# 802.3dj D2.1

## Comment Resolution

## Common Track

Figure 174A-3—Test configuration for an xAUI-n

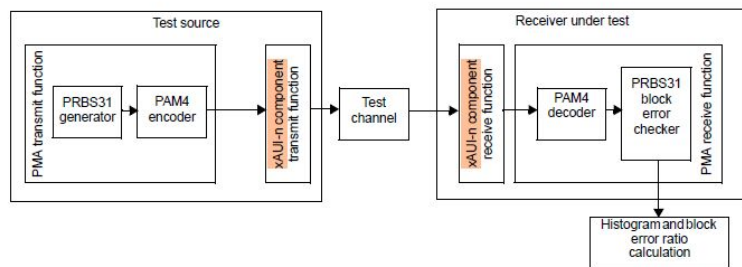
To be consistent with the rest of Annex 174A (see previous slide, 174A.10.4, Table 174A-1 footnote a, Table 174A-2 footnote a, Table 174A-3 footnote a), in Figure 174A-3, “xAUI-n component” should be changed to “AUI component”.

Editor's proposal is to adopted the changes as proposed above.
